P802.1ASds

Proposed resolutions for comments #75,
#40, and #74 against P802.1ASds-D0.1

Silvana Rodrigues (Editor)
(Huawei Technologies Co., Ltd.)
IEEE 802.1 Plenary meeting
March 2023

Figure 11-9—MDPdelayReq state machine

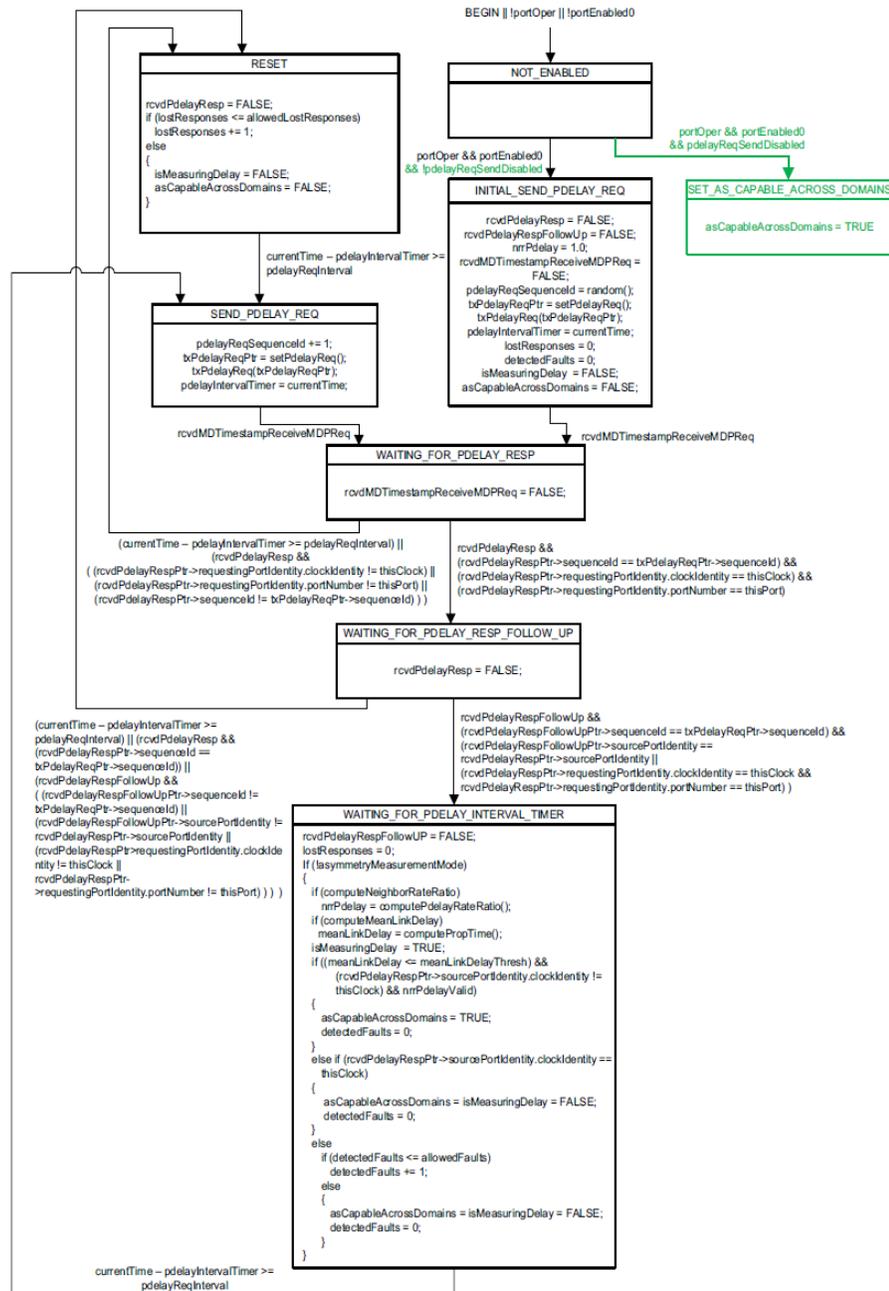
MDPdelayReq state machine for timeReceiver

- pdelayReqSendDisabled is FALSE
- The state machine runs normally: AsCapableAcrossDomains is set TRUE or FALSE depending on the execution of the state machine at the “WAITING_FOR_PDELAY_INTERVAL_TIMER” state

Clause 11.2.2 works for timeReceiver, no changes are needed

- At the timeReceiver port, if items a), b), c), and d) are satisfied then asCapableAcrossDomains is TRUE
- At the timeReceiver port, if items a), b), c), and d) are not satisfied then asCapableAcrossDomains is FALSE

- At the timeReceiver port, if asCapableAcrossDomains is TRUE, then item e) is satisfied.
- Item f) 1) is satisfied because both GptpCapableTransmit and GptpCapableReceive state machines shall be disabled, and according to Asdm, neighborGptpCapable is set to TRUE
- Therefore, asCapable is set to True
- At the timeReceiver port, if asCapableAcrossDomains is FALSE, the asCapable is set to FALSE, as item e) is not satisfied

Figure 11-9—MDPdelayReq state machine

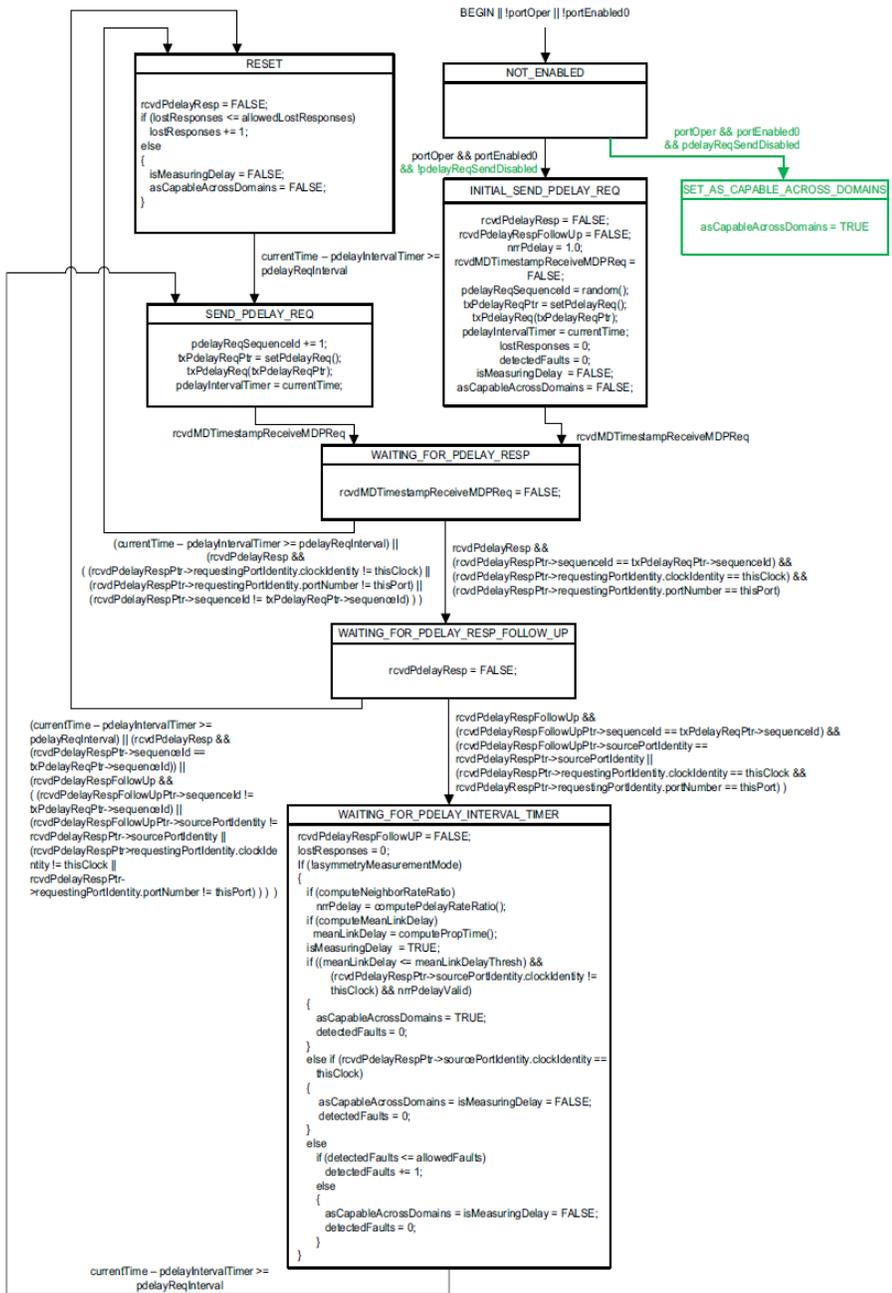
MDPdelayReq state machine for timeTransmitter

- pdelayReqSendDisabled is TRUE
- The state machine goes to “SET_AS_CAPABLE_ACROSS_DOMAINS” state and sets AsCapableAcrossDomains to TRUE
- timeTransmitter does not send Pdelay_Req,
 - Pdelay_Resp are not received at the timeTransmitter for HDE
 - No need to check whether or not Pdelay_Resp are received or meanLinkDelayThresh is exceeded, as timeTransmitter port does not measure meanLinkDelay

Clause 11.2.2 works for timeTransmitter

- At the timeTransmitter port, asCapableAcrossDomains is set to TRUE by the state machine
- At the timeTransmitter port, items a), b), c), and d) are not applicable, as the state machine sets asCapableAcrossDomains to TRUE. Need a small modification of clause 11.2.2, see slide 9.

- At the timeTransmitter port, asCapableAcrossDomains is set to TRUE, item e) is satisfied.
- Item f) 1) is satisfied because both GptpCapableTransmit and GptpCapableReceive state machines shall be disabled, and according to Asdm, neighborGptpCapable is set to TRUE
- Therefore, asCapable is set to True
- At the timeTransmitter port, asCapableAcrossDomains and asCapable are always TRUE for HDE

Figure 11-9—MDPdelayReq state machine

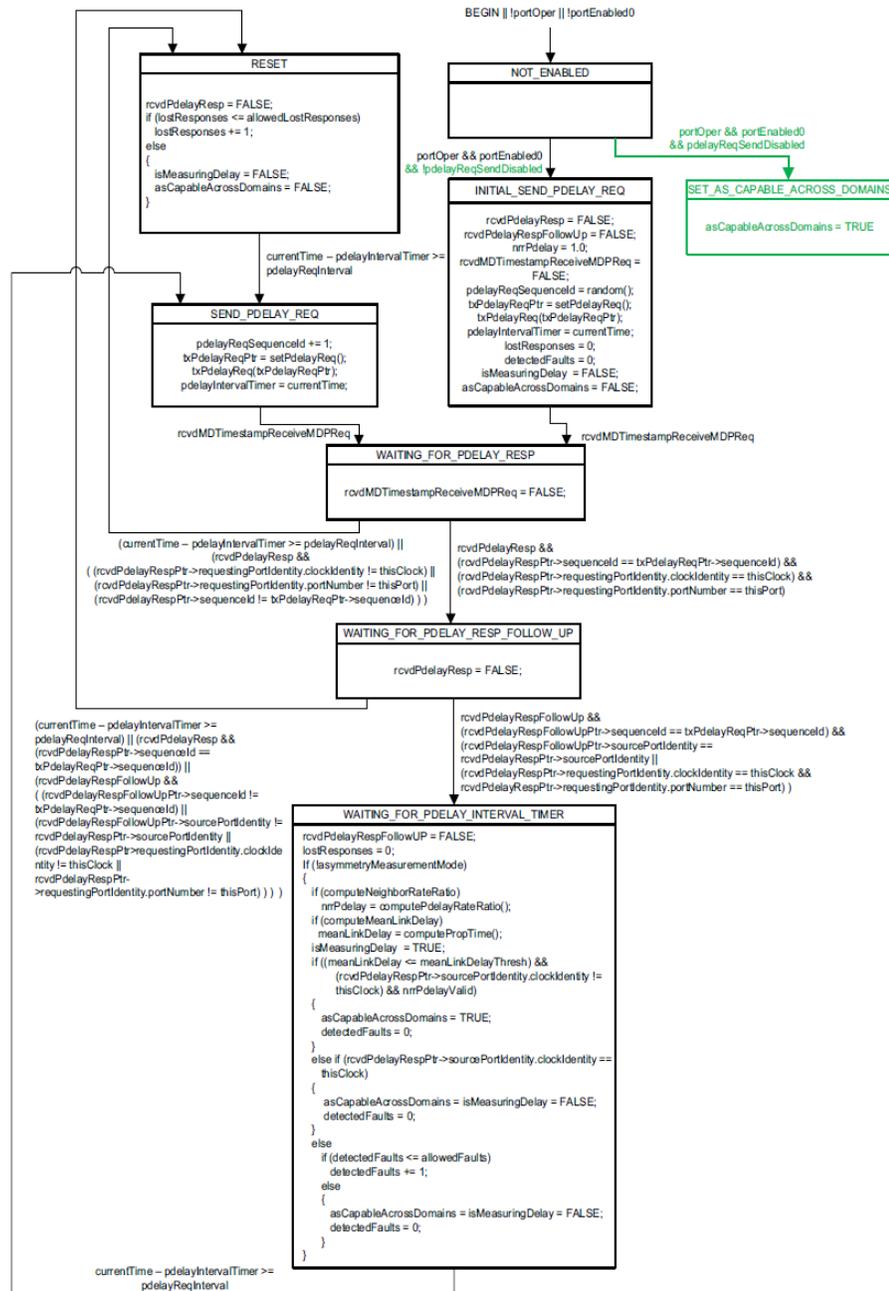
MDPdelayReq state machine

when pdelayReqSendDisabled is TRUE at the timeReceiver and at the timeTransmitter

- pdelayReqSendDisabled is TRUE
- The state machine goes to “SET_AS_CAPABLE_ACROSS_DOMAINS” state and sets AsCapableAcrossDomains to TRUE
- timeTransmitter and timeReceiver do not send Pdelay_Req
 - Transport-specific peer-to-peer delay mechanism is not used
 - No need to check whether or not Pdelay_Resp are received or meanLinkDelayThresh is exceeded, as there is no measurement done for meanLinkDelay

Clause 11.2.2 works for timeTransmitter and timeReceiver when pdelayReqSendDisabled is TRUE for both

- At the timeTransmitter and timeReceiver ports, asCapableAcrossDomains is set to TRUE by the state machine (as **pdelayReqSendDisabled is TRUE on both ports**)
- At the timeTransmitter port and timeReceiver port (**when pdelayReqSendDisabled is TRUE**), items a), b), c), and d) are not applicable, as the state machine sets asCapableAcrossDomains to TRUE. Need a small modification of clause 11.2.2, see slide 9.

- At the timeTransmitter port and timeReceiver port (**when pdelayReqSendDisabled is TRUE**), asCapableAcrossDomains is set to TRUE, item e) is satisfied.
- Item f) 1) is satisfied because both GptpCapableTransmit and GptpCapableReceive state machines shall be disabled, and according to Asdm, neighborGptpCapable is set to TRUE
- Therefore, asCapable is set to True
- At the timeTransmitter port and timeReceiver port (**when pdelayReqSendDisabled is TRUE**), asCapableAcrossDomains and asCapable are always TRUE

The per-port global variable asCapableAcrossDomains is set by the MDPdelayReq state machine (see 11.2.19 and Figure 11-9). For a port attached to a full-duplex point-to-point PTP Link **or to an HDE link**, asCapableAcrossDomains shall be set to TRUE if and only if **either**:

1) **It ~~is~~** is determined, via the peer-to-peer delay mechanism, that the following conditions hold for the port:

2) **pdelayReqSendDisabled is set to TRUE**
